RECALL CAMPAIGN BULLETIN

Reference: NTB10-031a

VOLUNTARY SAFETY RECALL CAMPAIGN 2006 AND 2008 FRONTIER, XTERRA, PATHFINDER FUEL GAUGE INACCURACY

This bulletin has been amended. Changes have been made to Step 6 of the Service Procedure. Please discard previous versions of this bulletin.

Figure 5

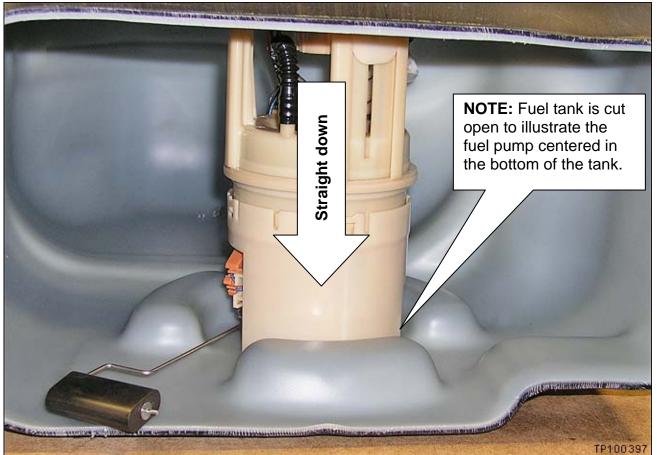
6. Carefully reinstall the fuel pump assembly back into the fuel tank.

IMPORTANT:

- Use a new seal (O-Ring).
- <u>Make sure</u> the fuel pump assembly is installed <u>straight down</u> into the tank as shown in Figure 5.
